A G E N D A
FARRAGUT MUNICIPAL PLANNING COMMISSION

October 15, 2015
7:00 p.m. Farragut Town Hall

**MINUTES
FARRAGUT MUNICIPAL PLANNING COMMISSION**

REPORT TO THE FARRAGUT MUNICIPAL PLANNING COMMISSION

Tree Preservation / Removal Plan

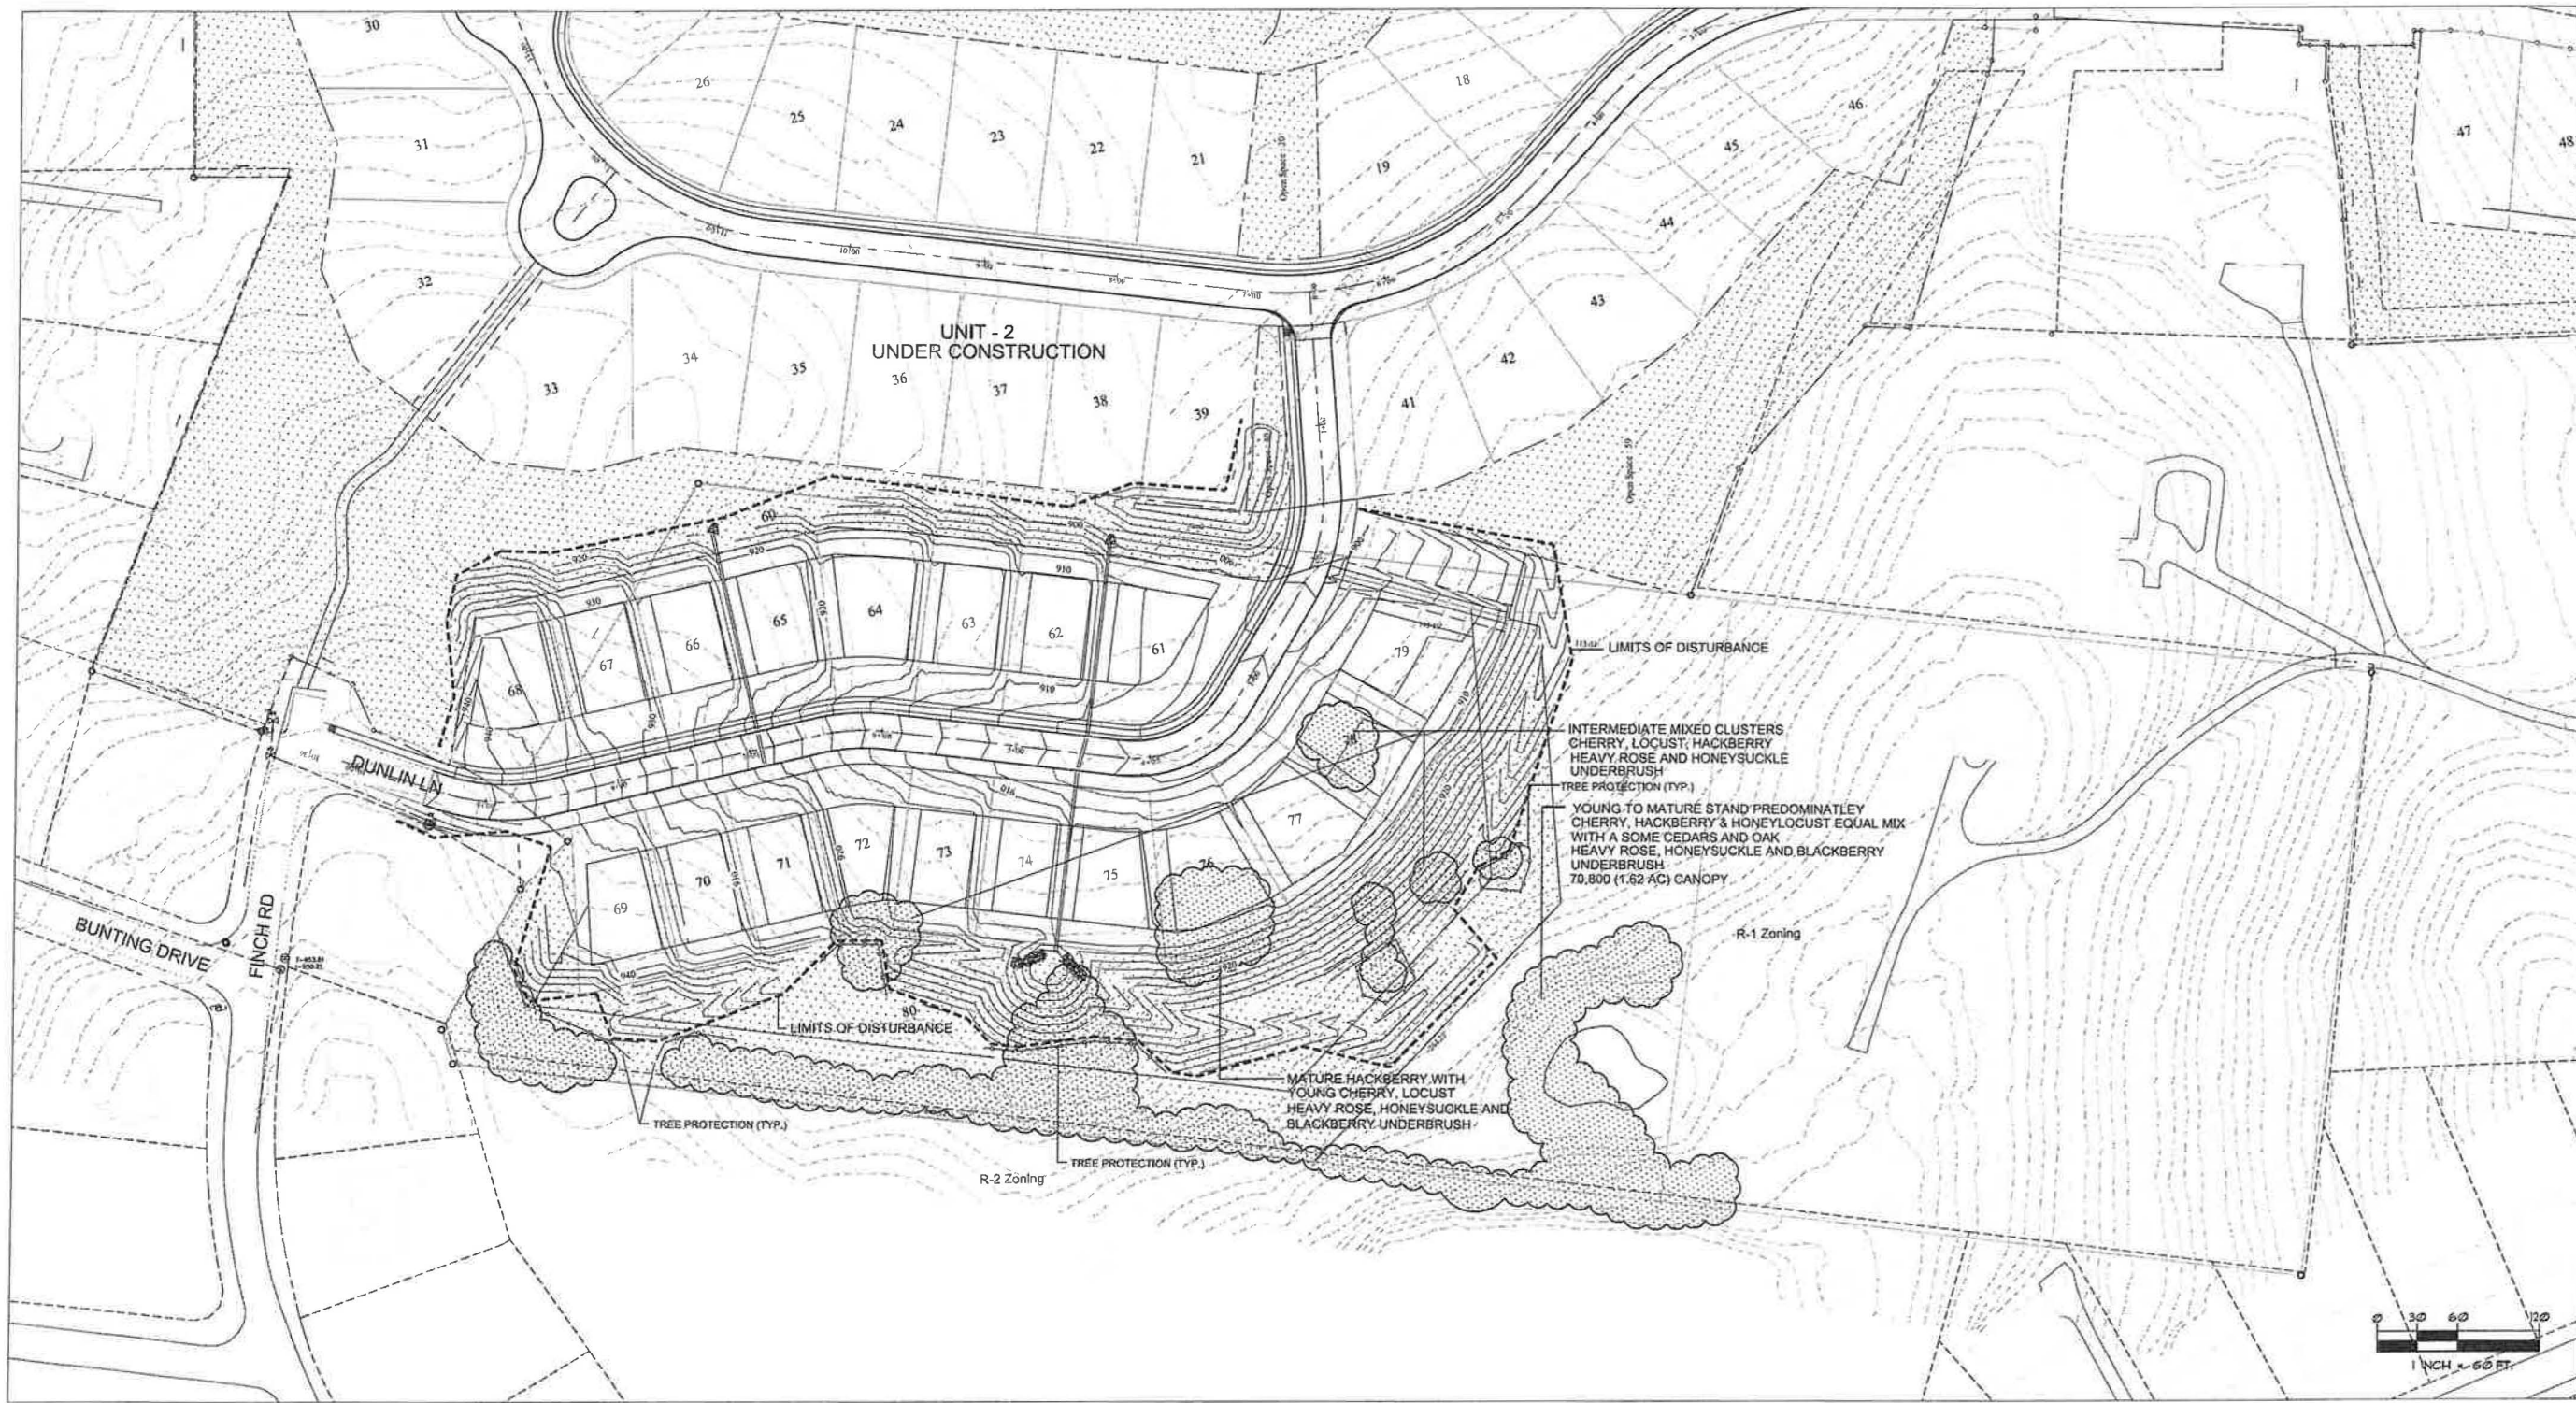
- 11) Please show the location for all tree protection fencing on the tree preservation/removal plan;
- 12) The street light globe glass must be frosted. Please note on Sheet 4;

a3.1-2

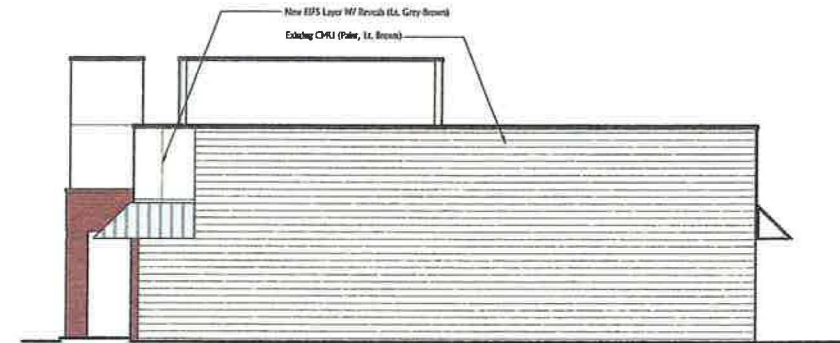
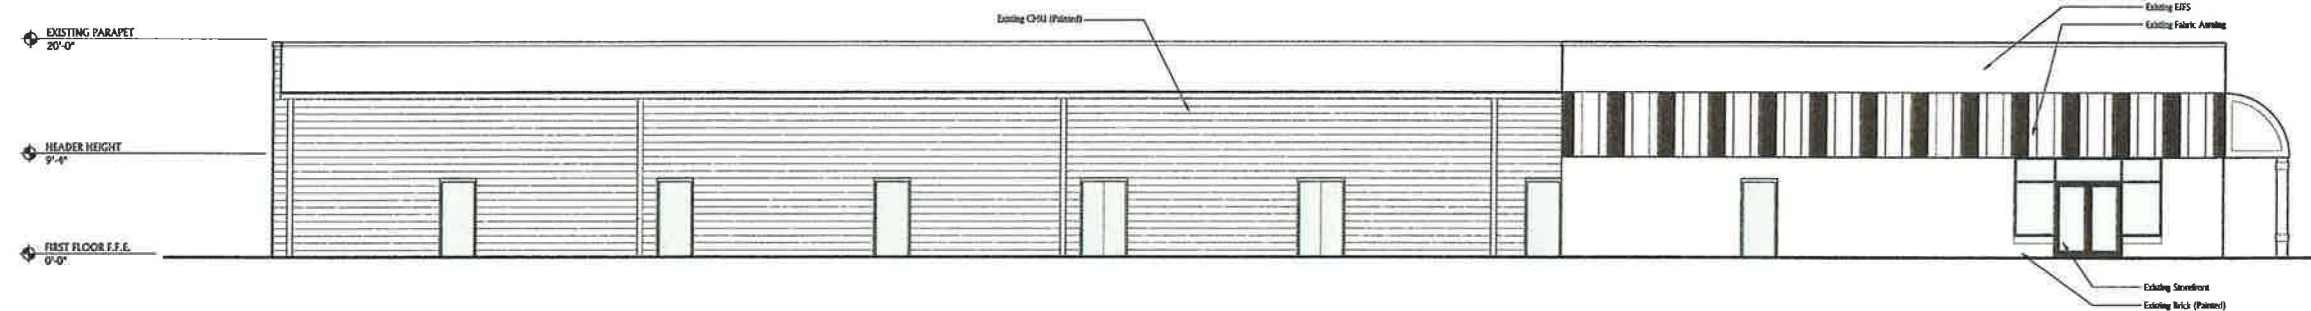
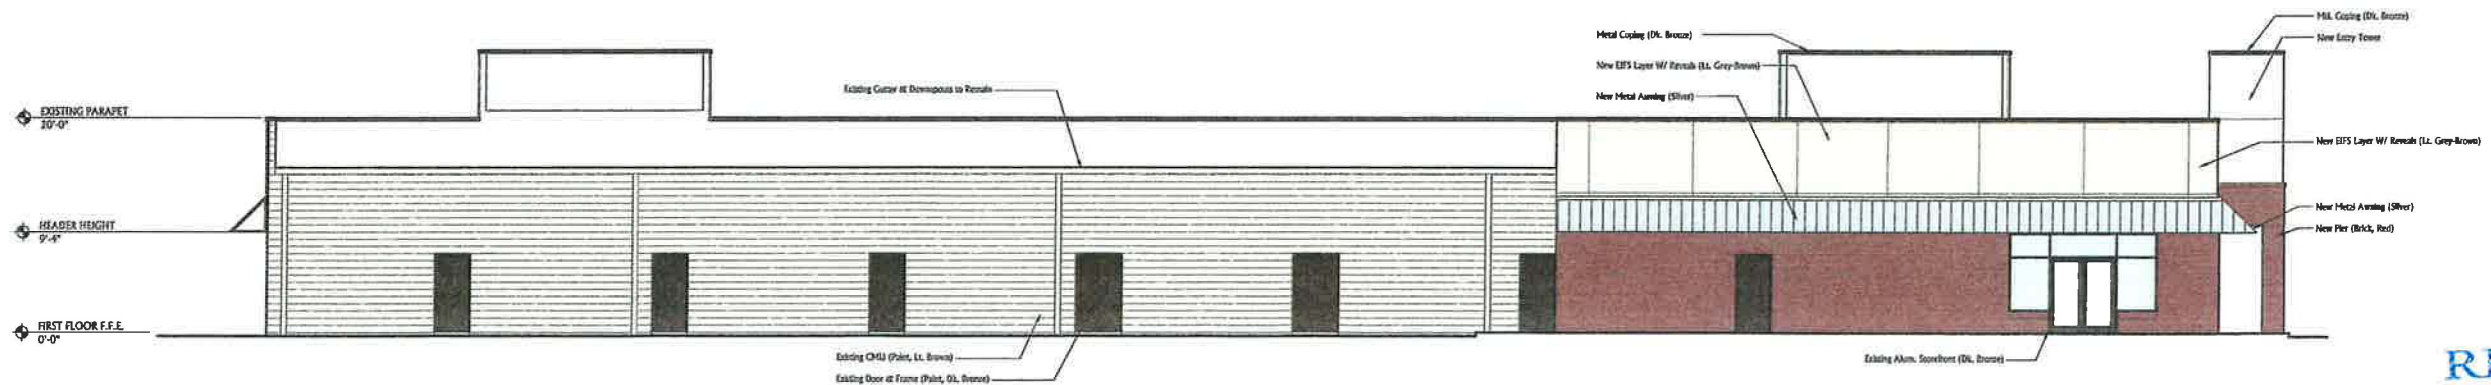
- 2) Please sequentially number the sheets 1 of ..., 2 of ..., 3 of ... ;
- 3) Please include in a plan note that this site plan is for a façade renovation only and that no modifications or expansions to the site are proposed at this time;

FRONT ELEVATION
1/4"=1'-0"

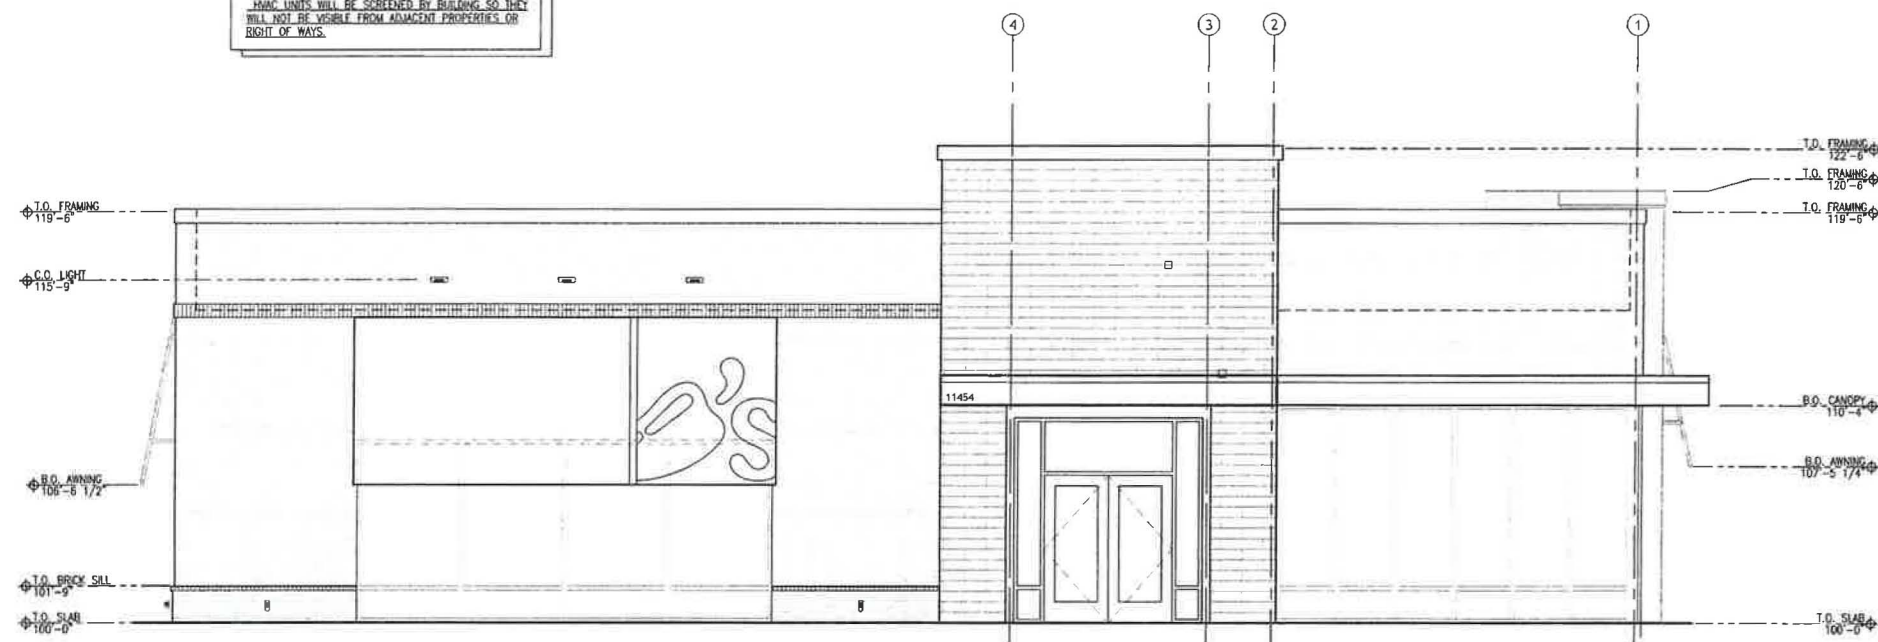
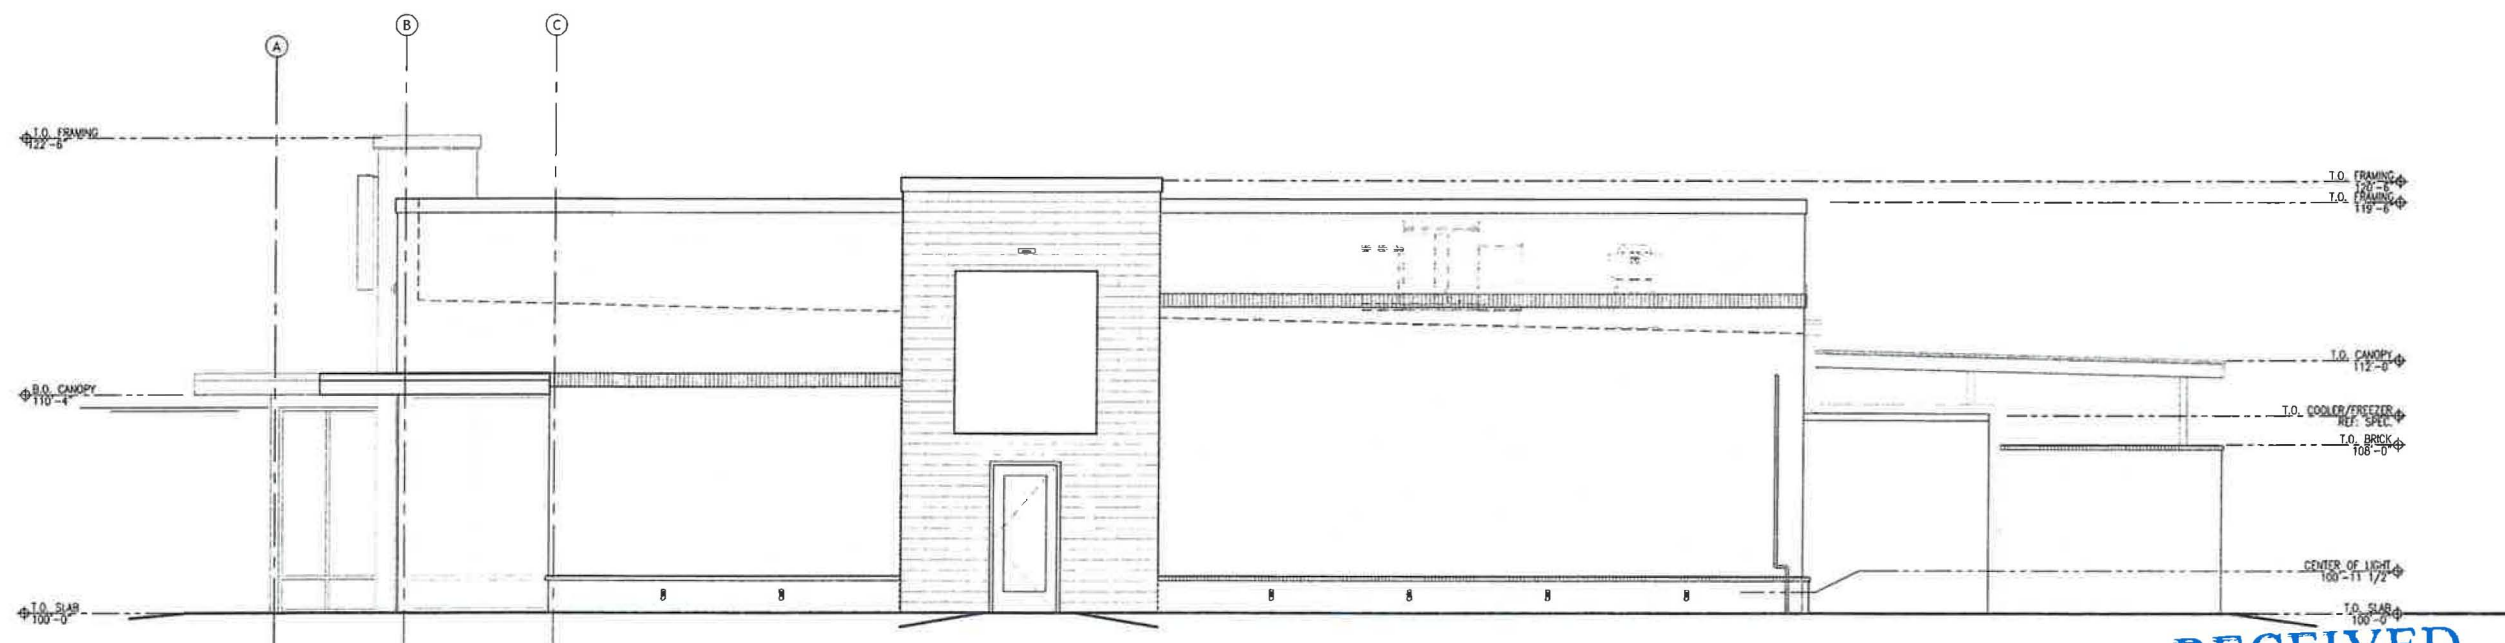
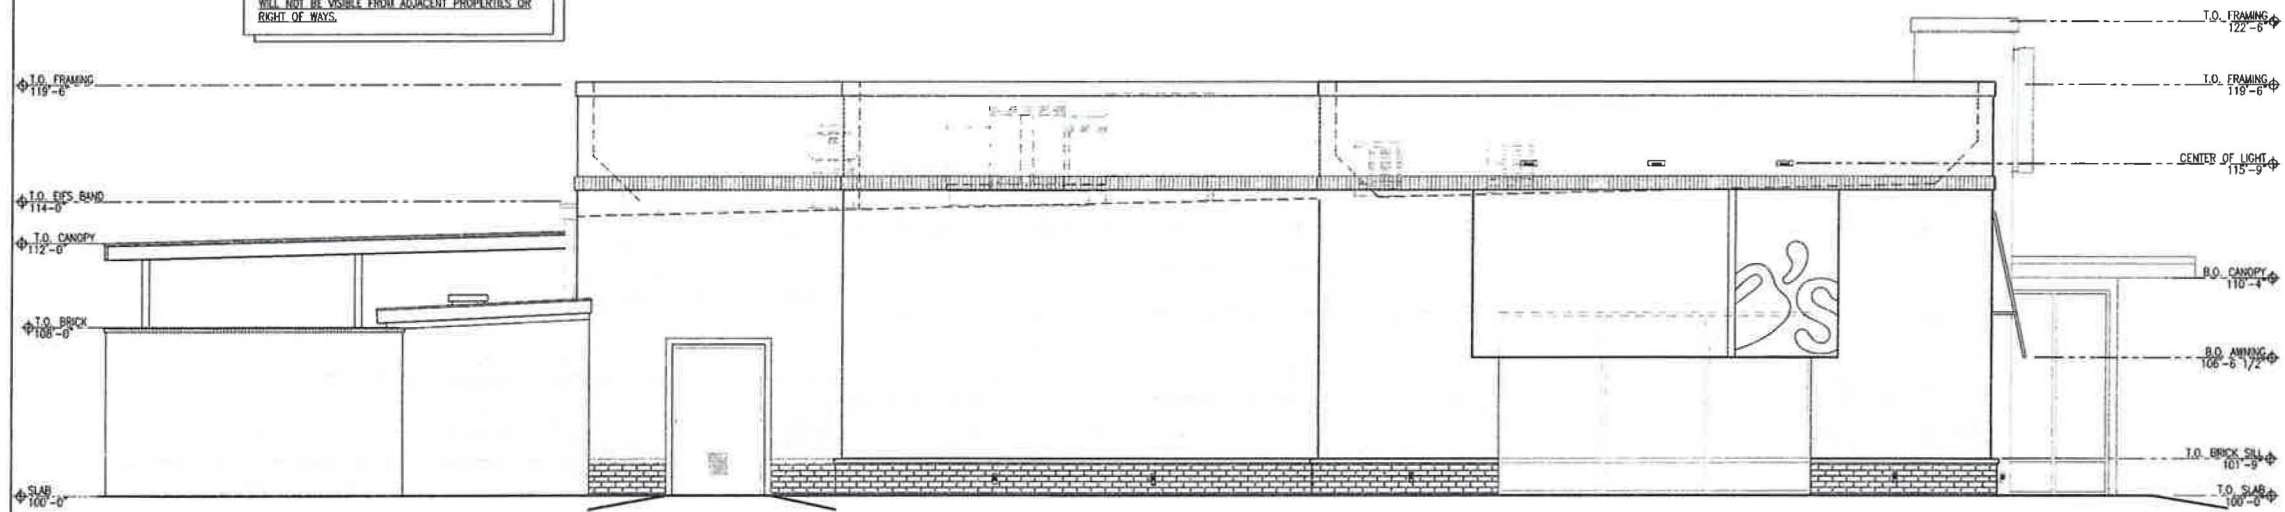
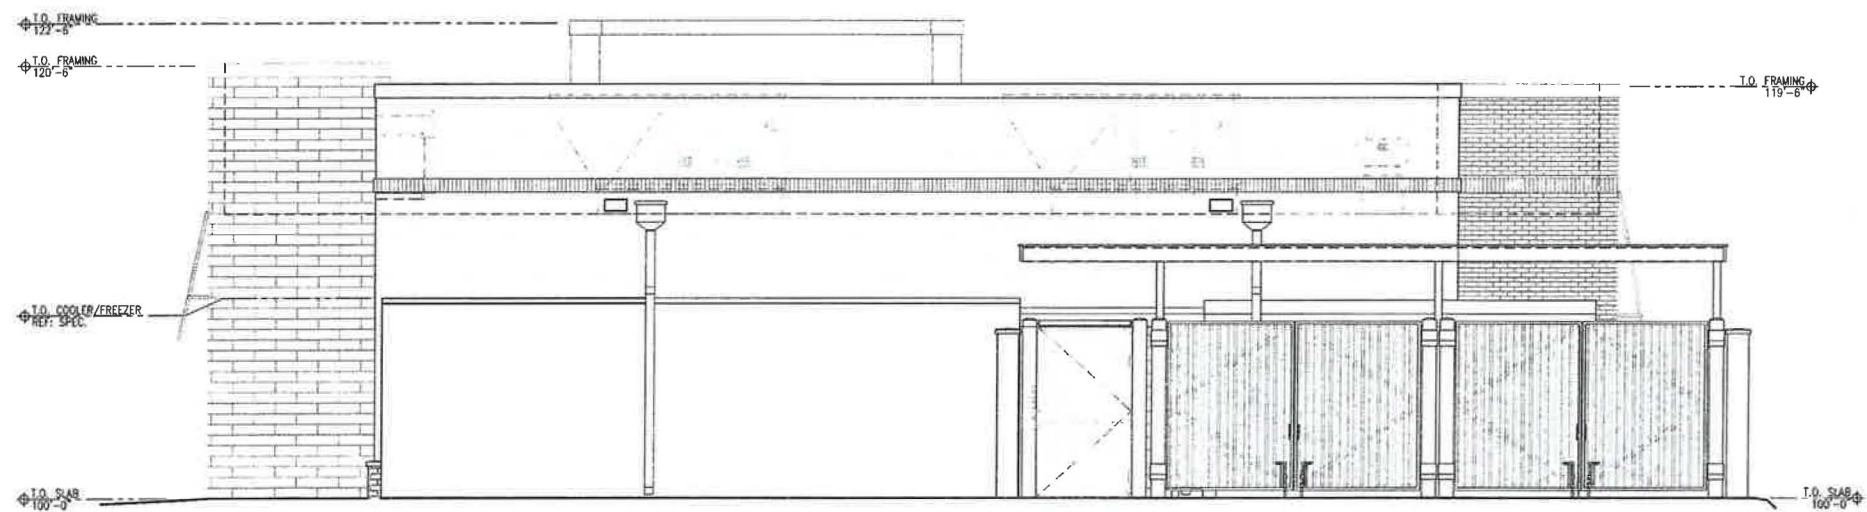
- a) Please re-number the index page sheets and the sheets in the submittal to match what is in the plan set;
- b) Please include all information on the 24 x 36 inch site plan sheets. For example, the HVAC units shown as screened by the building to verify they will not be visible from adjacent properties or rights of ways;

NOTE:
HVAC UNITS WILL BE SCREENED BY BUILDING SO THEY
WILL NOT BE VISIBLE FROM ADJACENT PROPERTIES OR
RIGHT OF WAYS.
